Docket Item # 4
BAR CASE #2010-0325

BAR Meeting
December 15, 2010

ISSUE: Signage

APPLICANT: CHLN, Inc. (Chart House Restaurant)

Figure 5. Details for illuminated sign on west elevation.

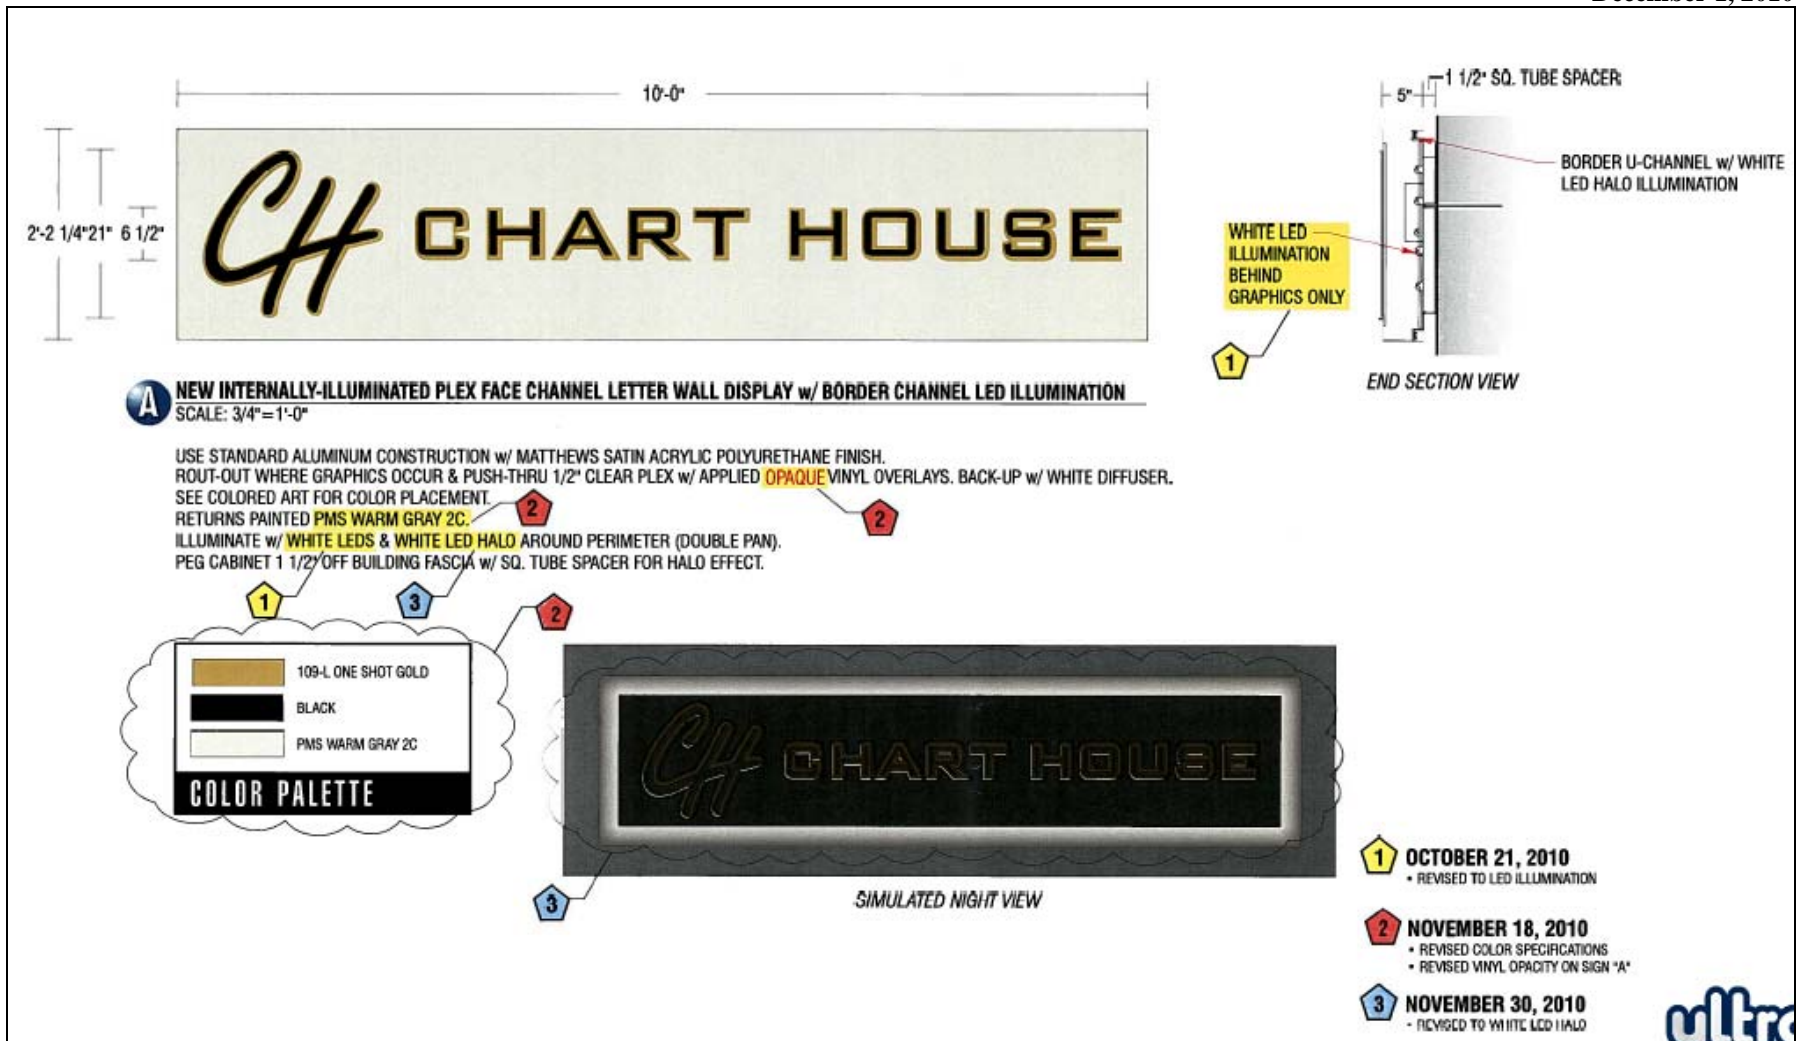
However, because the proposed LED lighting is a new technology and Staff has limited experience evaluating the intensity of the light from the application material provided, we recommend that the intensity of the illumination be subject to staff review and approval in the field. The applicant's representative verified that the intensity could be revised in the field, if necessary. The revised design is appropriate and consistent with the *Design Guidelines*. Therefore Staff recommends approval of the sign package with the condition noted above.

STAFF RECOMMENDATION: Staff recommends approval of the application, subject to Staff approval of the intensity of the LED illumination in the field.
